The Future For Uplift On Cairngorm – Environmental Aspects

With the Funicular currently out of action and its future unknown, the recently published SE Group addendum into uplift a Cairn Gorm ([see here](#)) is ostensibly recommending the creation of **8.7 hectares** of new ski terrain in Coire Cas as part of their revised plans. This post explains why this figure is wrong and far more ground will be affected.

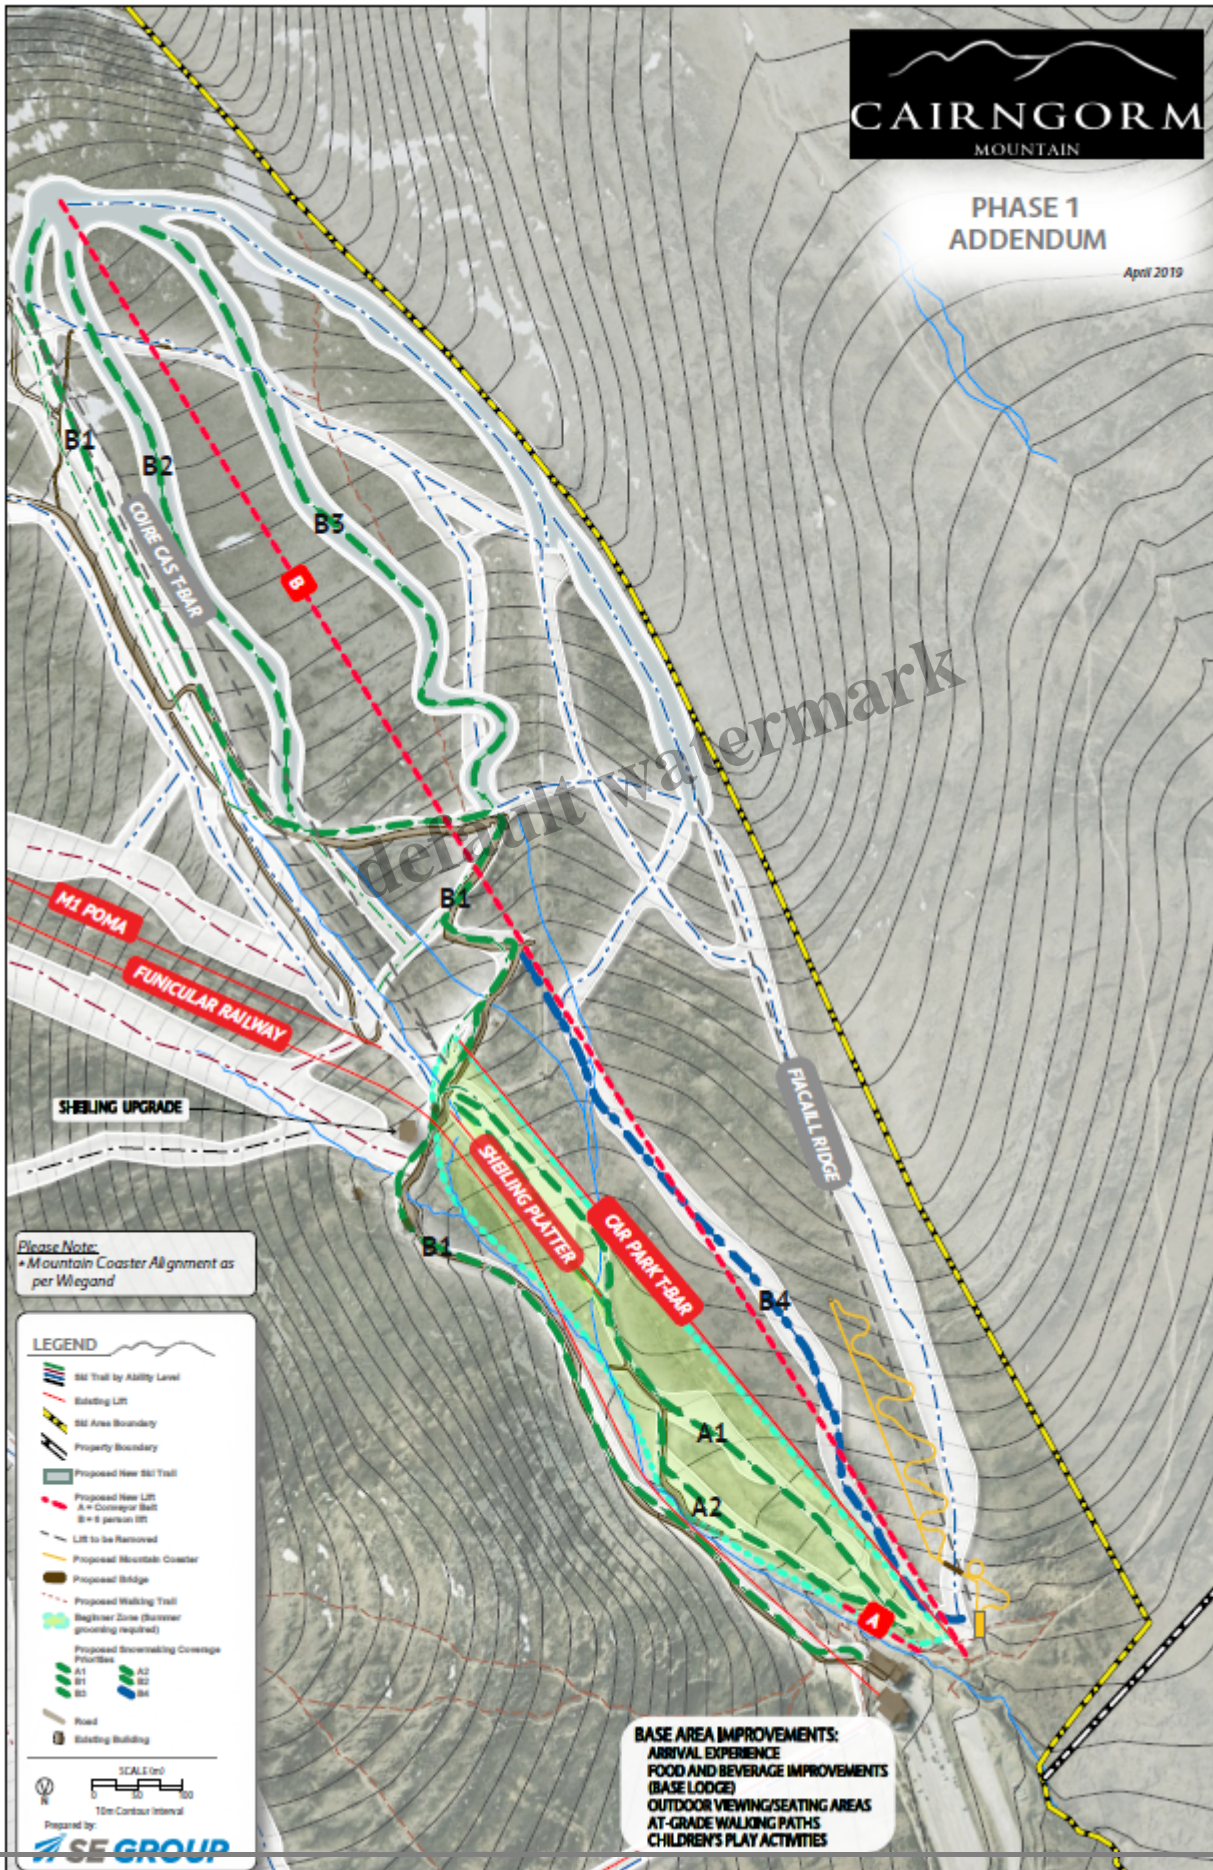
Looking at the second table on terrain costs there is no figure for the size of the beginner zone, so I had assumed from the Snowmaking chart that it is 3.1 hectares or 31,000 sq. m. I have now done a rough measurement of the size of the beginner zone and found it is probably over **6 hectares or 60,000 sq. m.**

This would alter the row for “Total of New Terrain”, including the beginner zone, to approx. **15.0 hectares or 150,000 sq. m.**, not 8.7 hectares, (strangely enough the area proposed for snowmaking is 15.9 hectares), and a capital cost of **£525,000** not £404,410.

If we take a look at the map of the proposals, its very poorly labelled. The “new terrain” at the “top of B1” referred to in the table presumably means the area from the top of Lift B to the top of the current Cas tow.

Runs B2 and B3 are completely new terrain and have dimensions, by my measurements, of approximately (B2) 700m long x 34m wide, and (B3) 800m x 35m, which comes to about what is quoted in the table. However, while B2 is 2.4 hectares it needs 2.7 hectares of snowmaking, whereas B3 is larger at 2.8 hectares and yet only requires 2.4 hectares of snowmaking!

The status of run B4 on the map is unclear because although it is shown as an existing run there is nothing on the ground where it is depicted. The snowmaking table describes it as comprising 2.9 hectares or 29,000 sq. m. If that were added to the new terrain table, that would increase the “total of New Terrain” to almost 18 hectares or 180,000 sq. m. and the capital cost to £630,000.

B5 is not shown on the map either but appears to run from the top of lift B to... where exactly? The table describes it as “connecting to Fiacaille ridge” but from the size and colour of the area shown on the map it appears that it should have been described as “connecting to the top of the Fiacaille Ridge tow”. Not quite the same!

Correct me if this already exists, but the map is also showing a run that starts off from the top part of the Fiacaille Ridge tow up track for about 1/3rd of its length but then veers off to one side only rejoining near the bottom of the lift! Is this new terrain as well? If it is then it has not been included in the new terrain figures and, as it looks roughly the same size as B5, could add another 32,000 sq. m. at a cost of £112,000 giving a “total of new terrain” of about 212,000 sq. m. and a capital cost of £842,000.
